Addendum No. 2  
May 16, 2023

JSD Jefferson E.S.

## **ADDENDUM NO.2**

**PROJECT**      **Jefferson Elementary School Addition and Remodel**  
Jerome, Idaho

AGENCY REVIEW  
DRAWING NO.  
**SC2.0**  
UTILITY PLAN

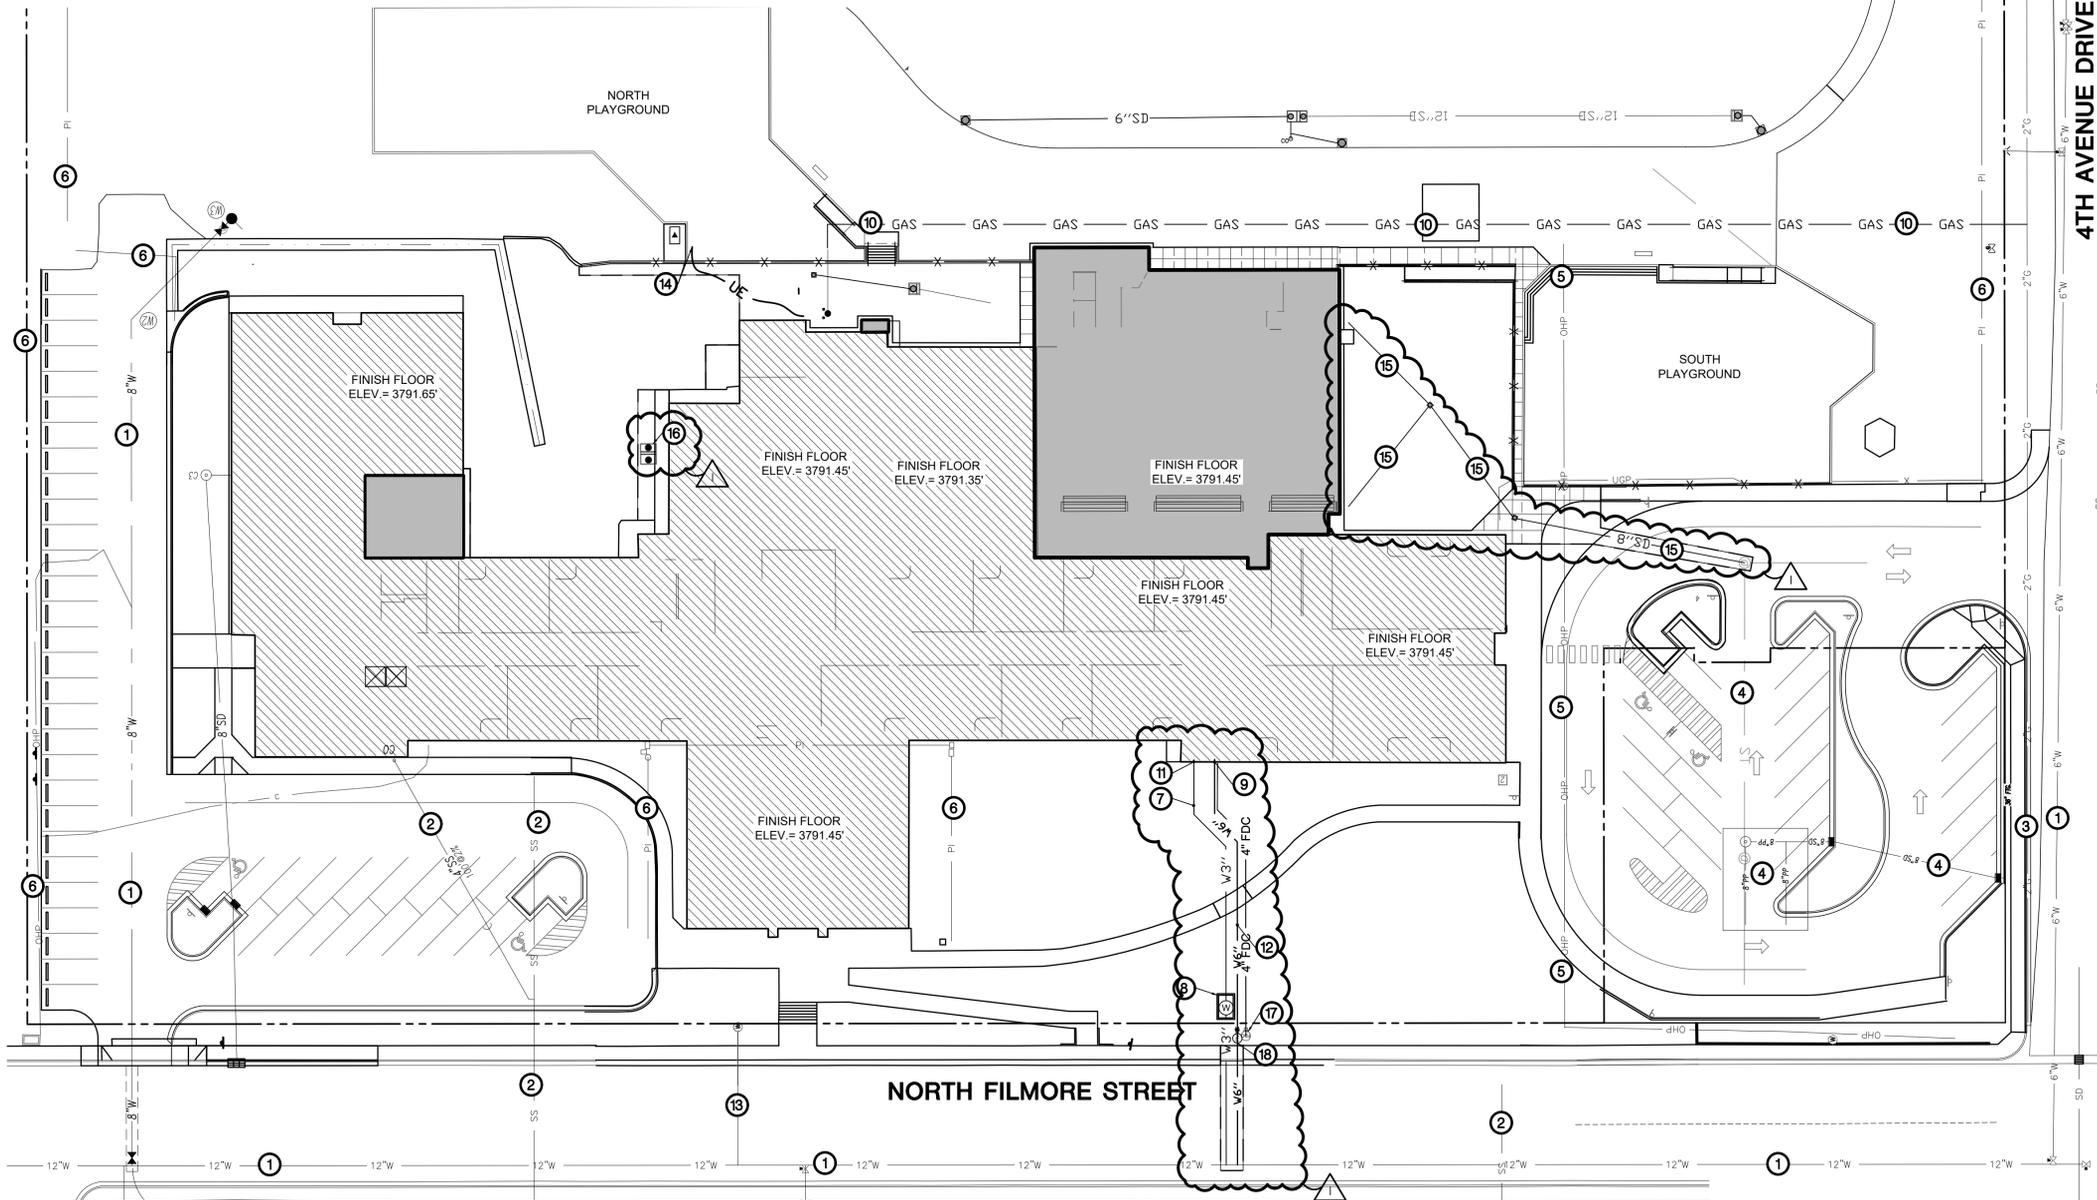
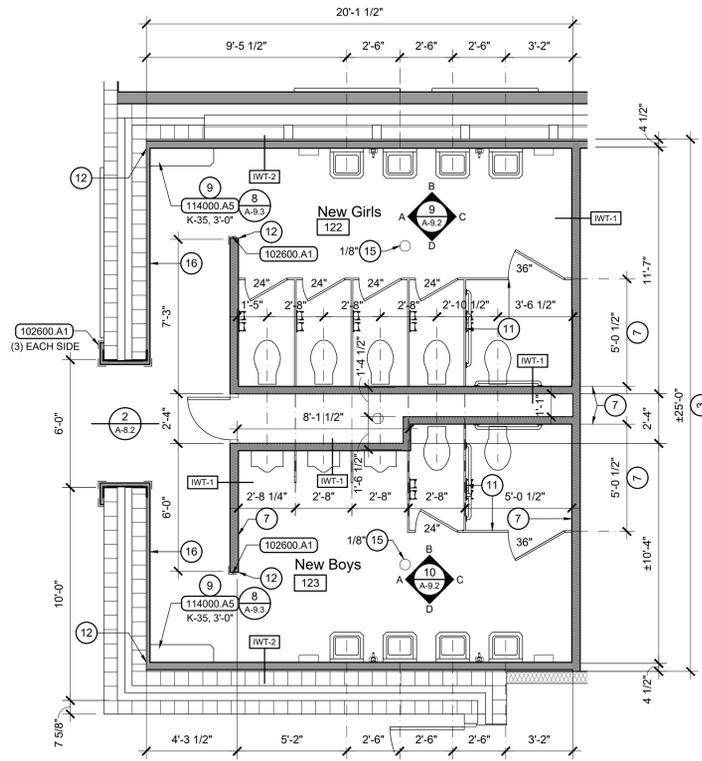
Sheet SC2.0:

See revised sheet with upsized fire service line, relocated FDC, added storm drain lines, and added grease interceptor, dated 5/16/23, attached to this Addendum.

DRAWN BY: MS  
CHECKED BY: WT  
DRAWING NO.  
**A-3.9**

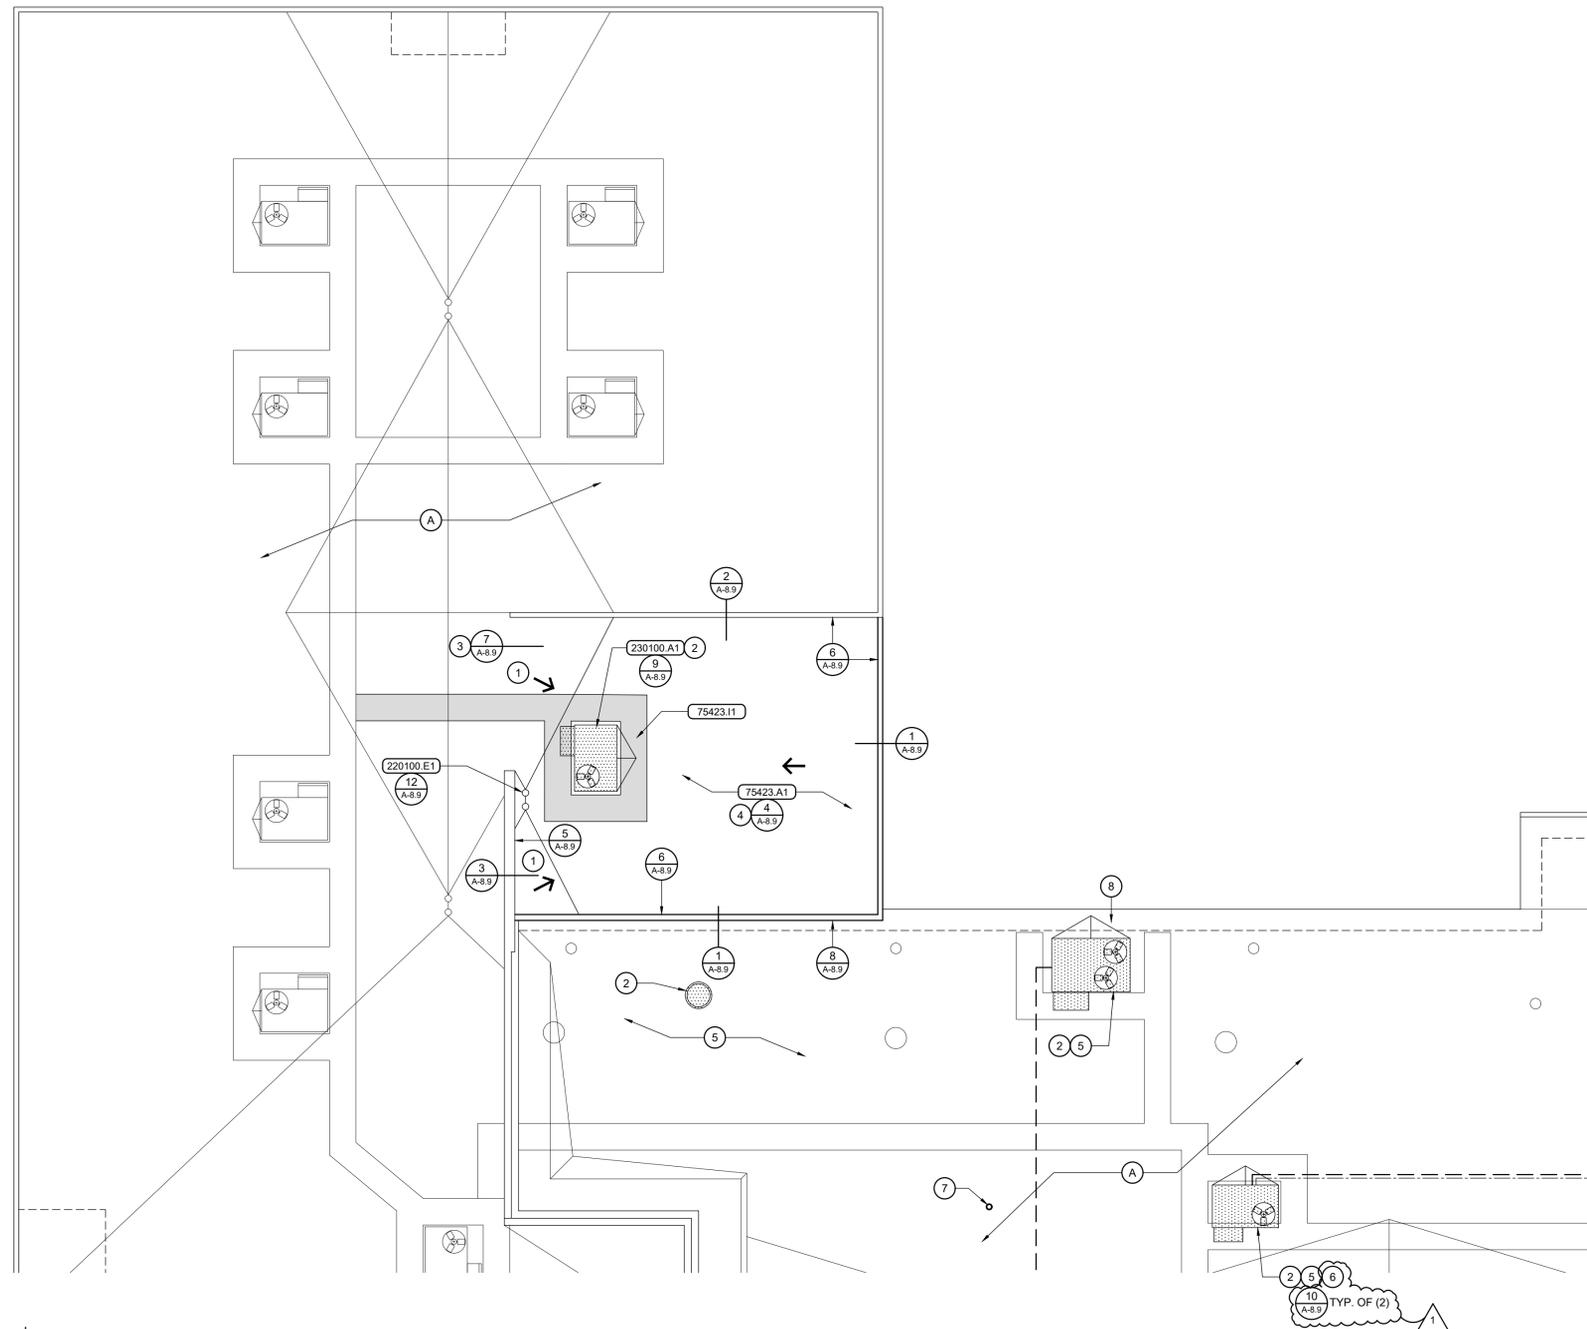
Sheet A-3.9:

See revised sheet with new window infill detail references, dated 5/16/23, attached to this Addendum.

DATE: February 24, 2023  
LKV PROJECT #: -  
REVISIONS:  
5/16/23  
DRAWN BY: MS  
CHECKED BY: WT  
Agency Review  
DRAWING NO. A-6.2

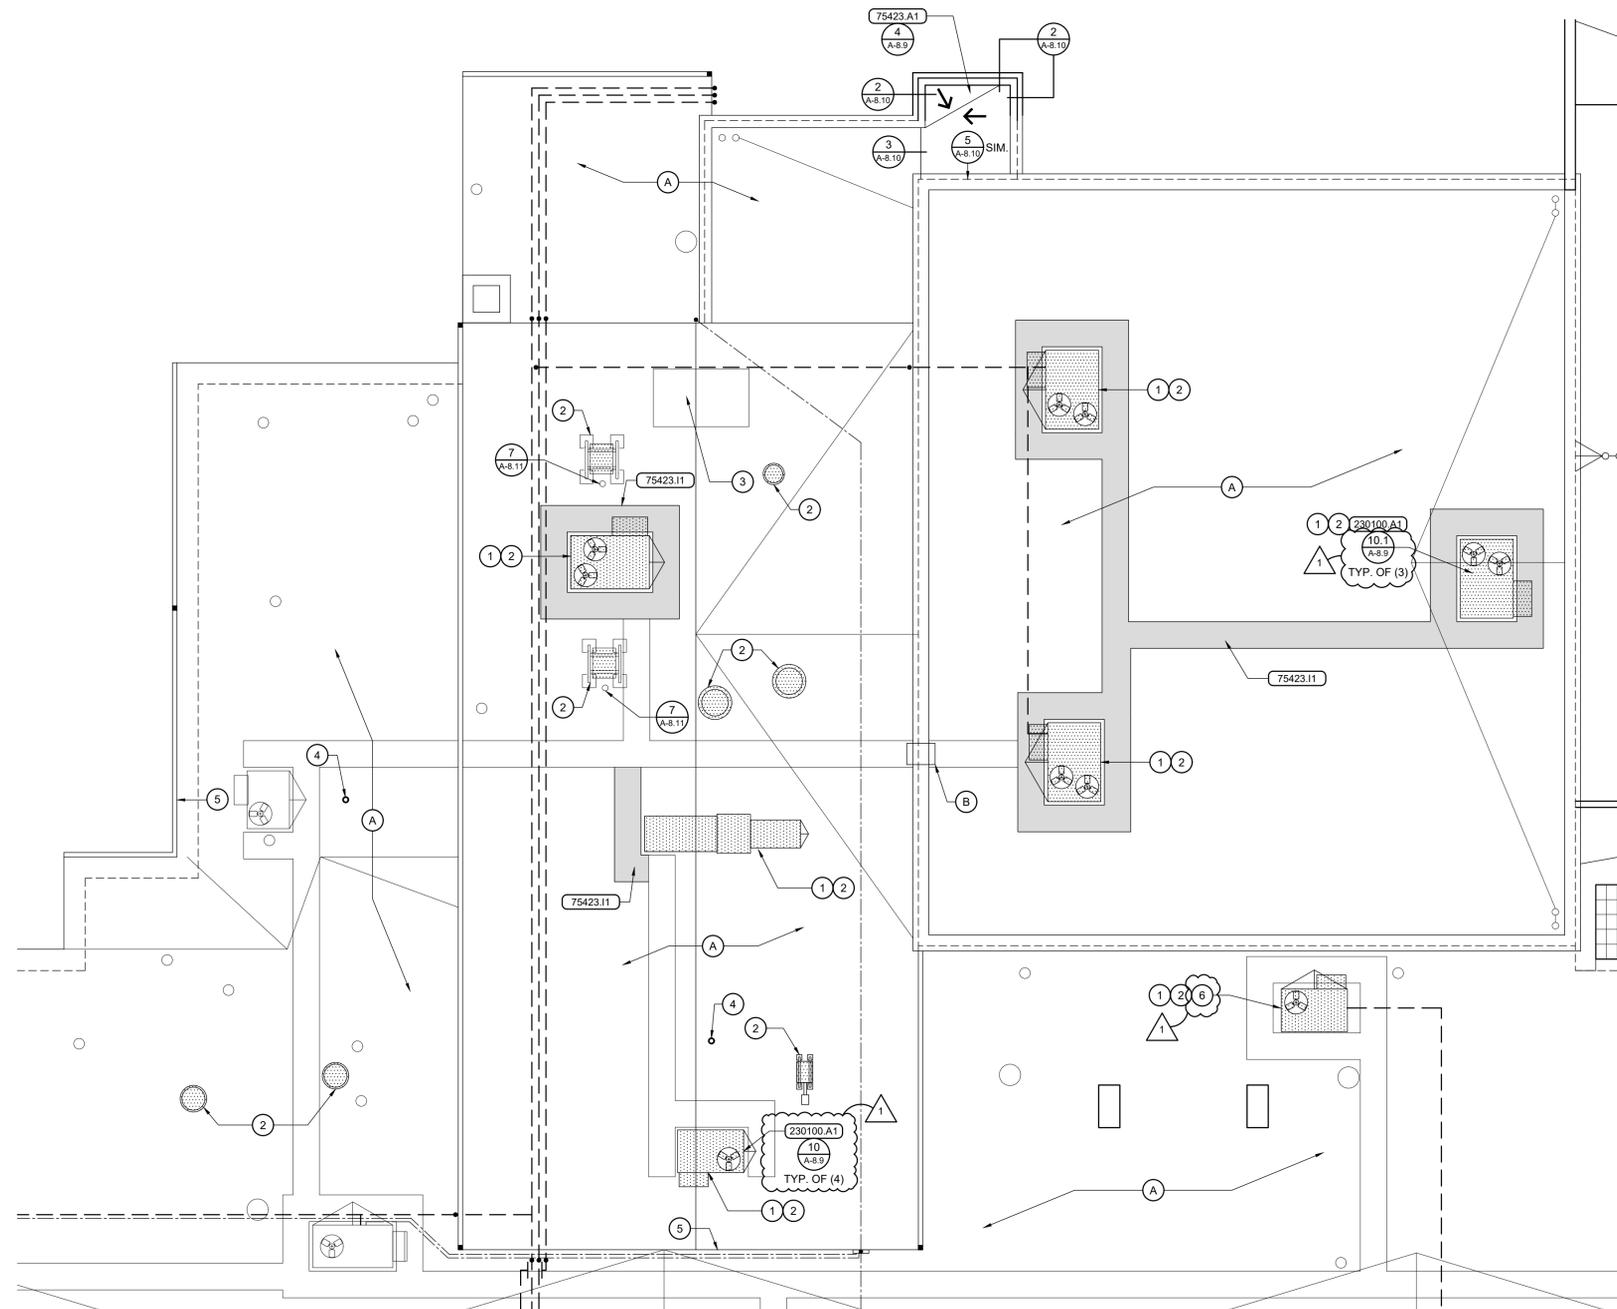
Sheets A-6.2, A-6.3, A-6.4, A-6.5, and A-6.6:

See revised Sheets A-6.2 – A-6.6 containing revised and additional notes and detail references, dated 5/16/23, attached to this Addendum.

A-8.8

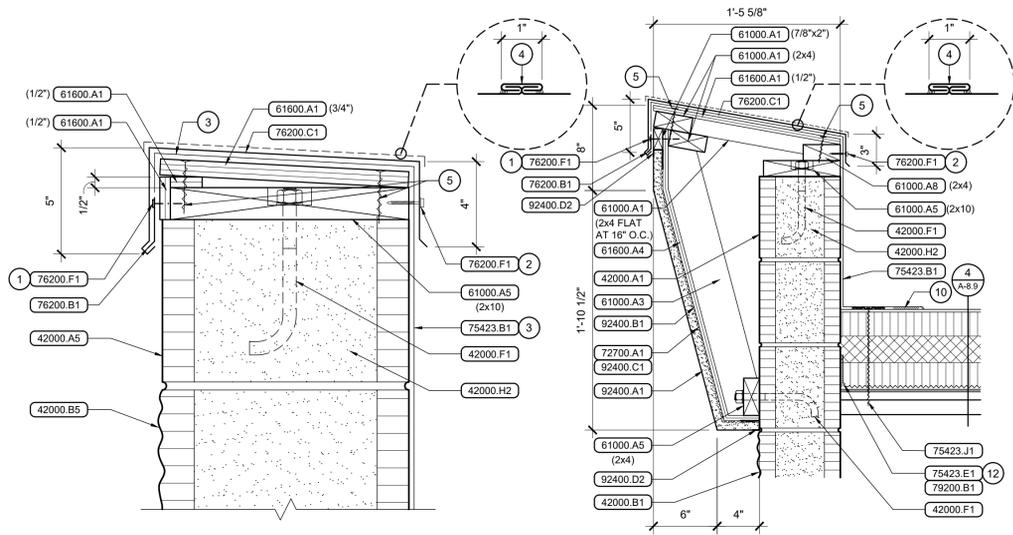
Sheet A-8.8:

See revised sheet with new Window Infill Detail 9, dated 5/16/23, attached to this Addendum.

**S1.22**  
AREA B ROOF FRAMING  
PLAN

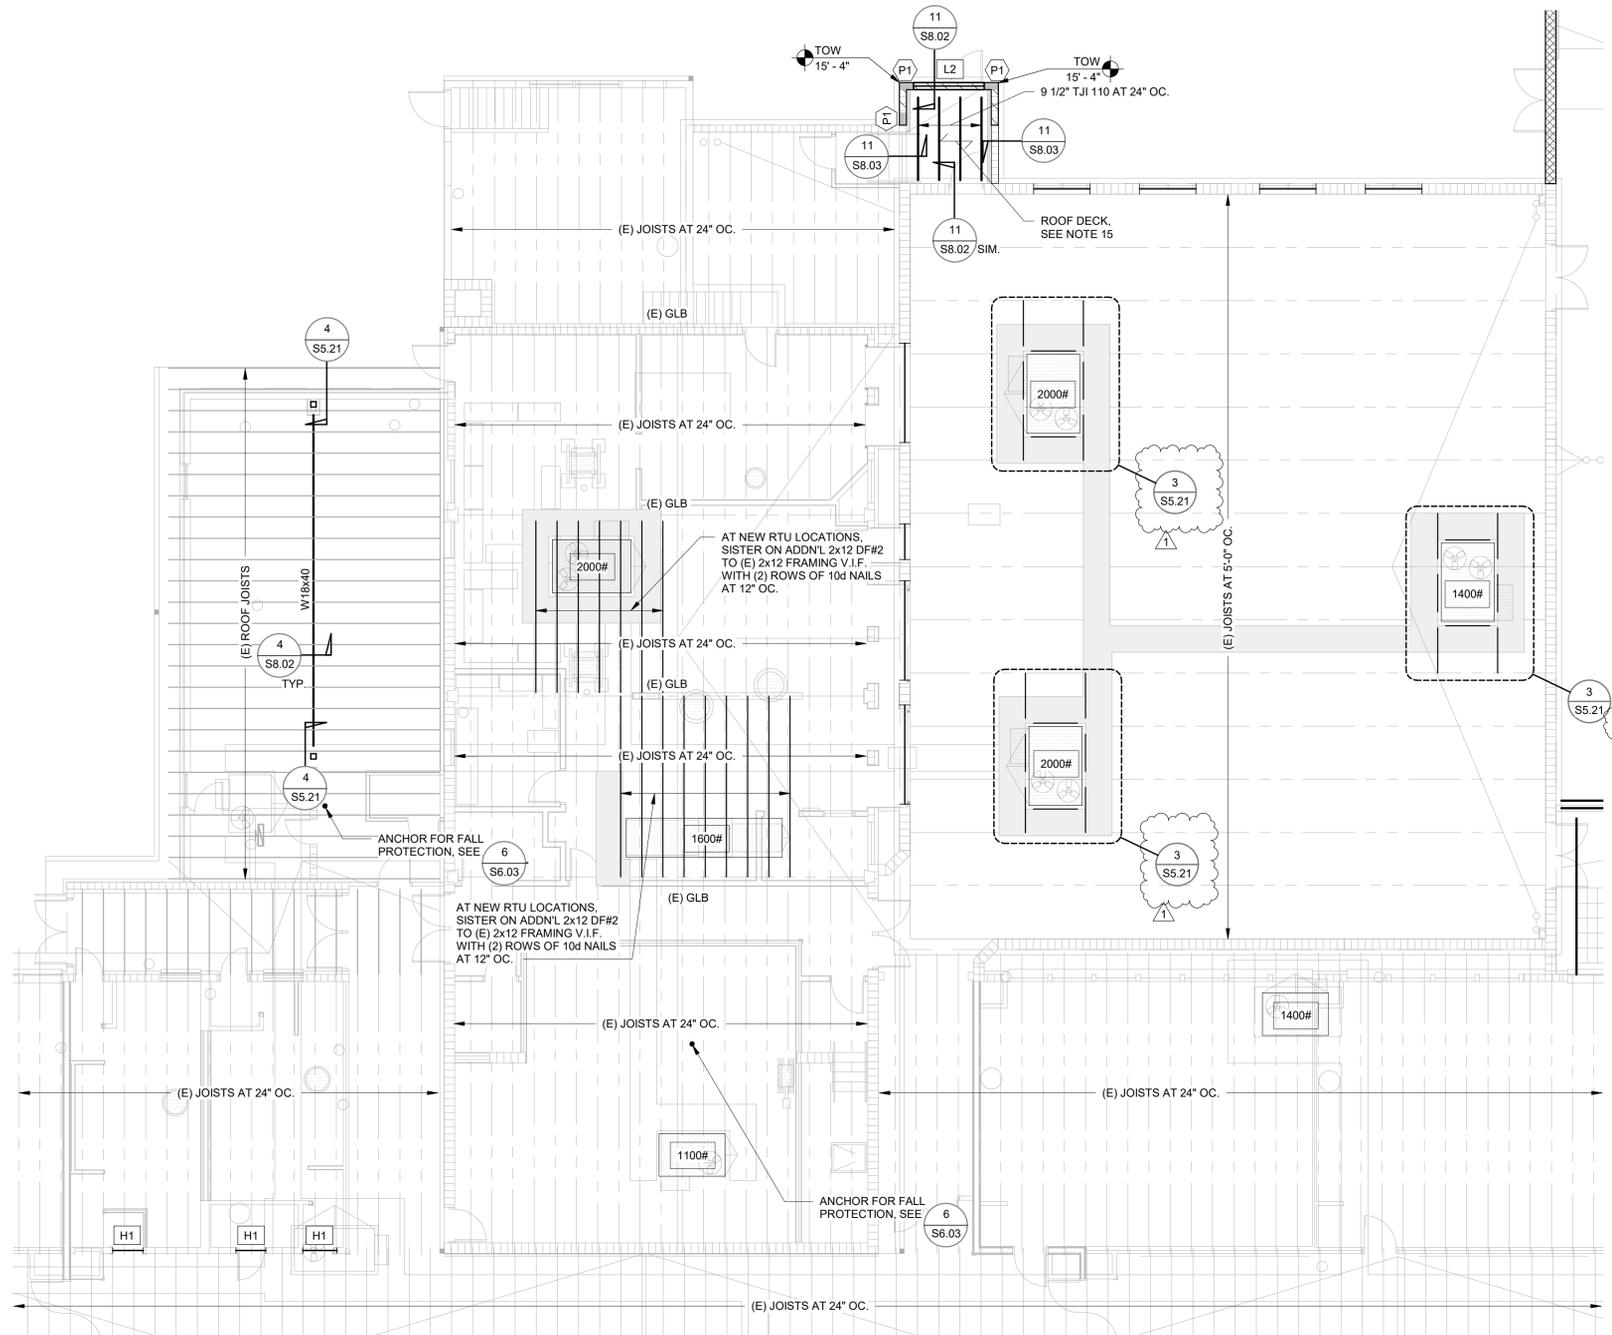
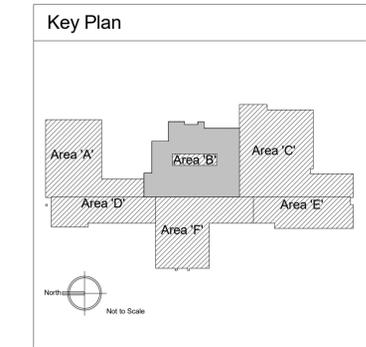
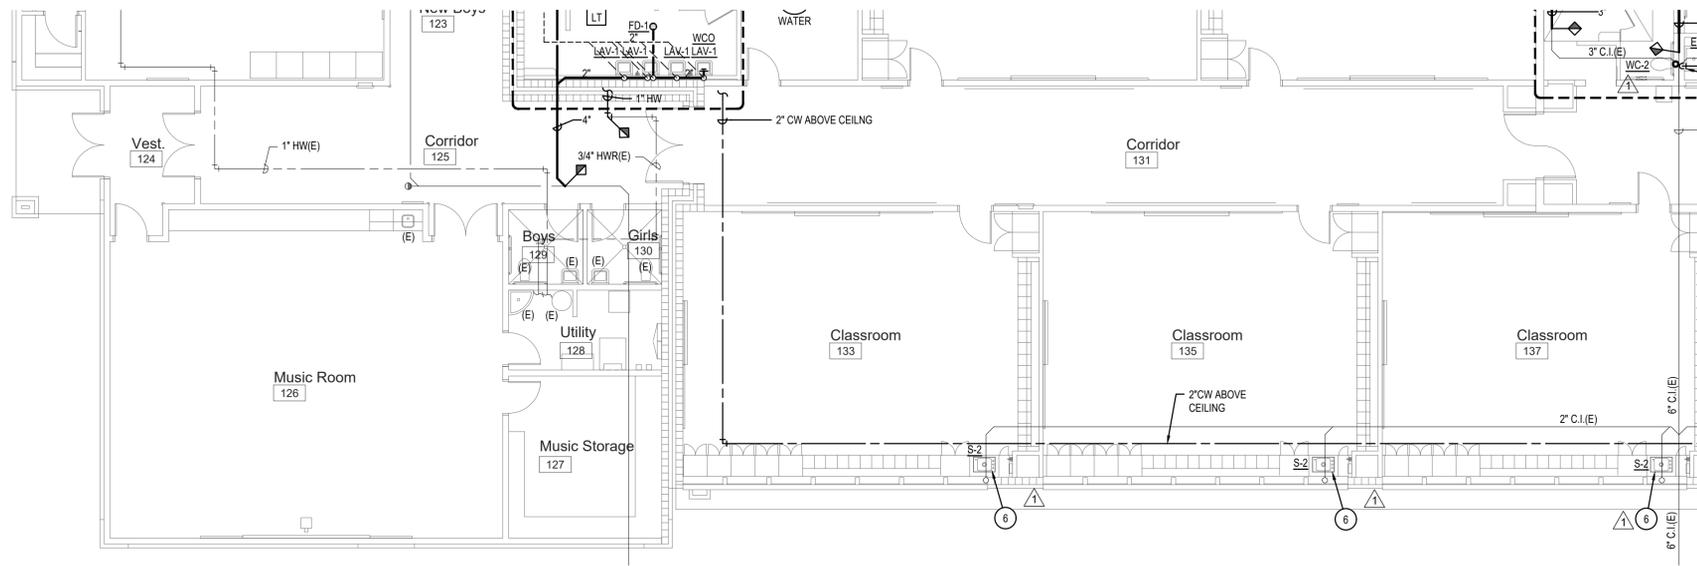
SHEETS S0.01 and S1.22:

See revised sheets for structural clarification related to providing reinforcing for the replacement RTU unit curbs at the cafeteria roof, dated 5/16/23, attached to this Addendum.
